ENCLOSURE 1
(TO SAFETY EVALUATION)

TECHNICAL EVALUATION REPORT
TECHNICAL SPECIFICATION IMPROVEMENT ANALYSIS
FOR BWR ISOLATION ACTUATION INSTRUMENTATION
NOT COMMON TO RPS AND ECCS

Final Report, Revision 1
April 2, 1990

U.S. Nuclear Regulatory Commission
Washington, D.C. 20555

Figure 2.1

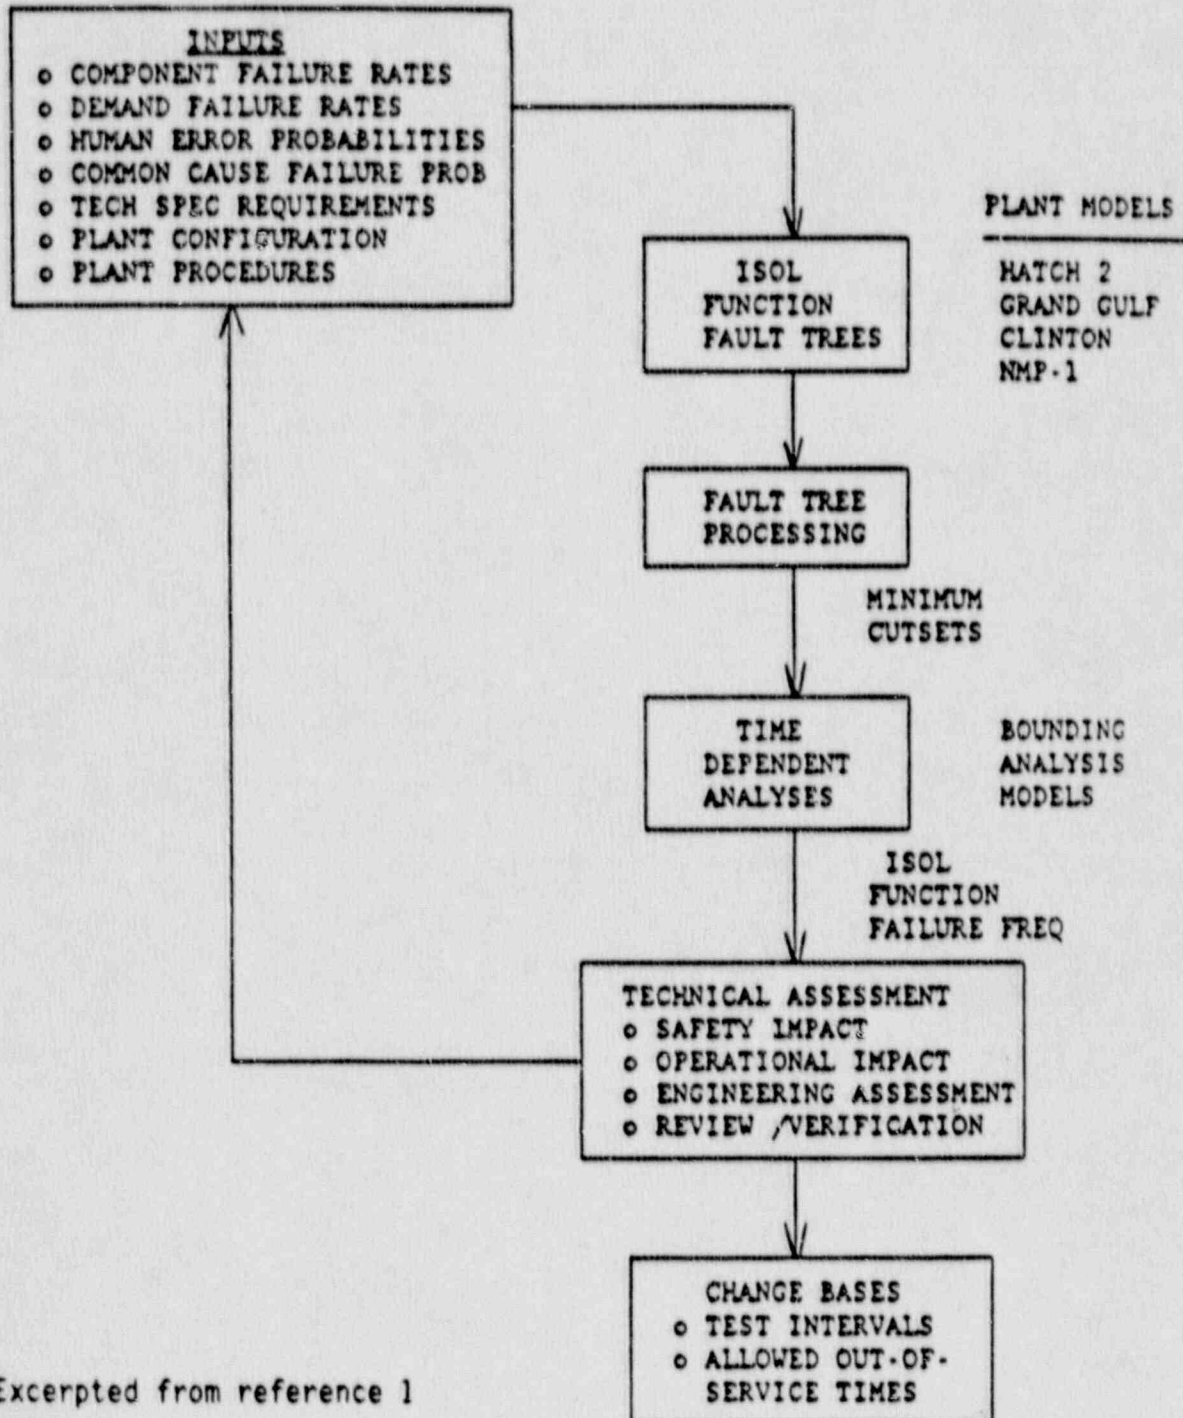
Figure 2.1 illustrates the GE general approach for assessing the impact of changes in plant Technical Specifications (1). The objective is to evaluate the impact of STI and AOT changes on plant risk in terms of a change in core melt frequency (CMF). The analysis follows the state-of-the-art techniques in probabilistic risk assessment. This requires that relevant information, such as initiating event frequency, component reliability data (including both the time-dependent and time-independent failure rates), system descriptions, success criteria, etc., be collected and defined. Based on this information, functional/system fault trees for each relevant system are generated and analyzed to evaluate the impact of the proposed Technical Specification changes.
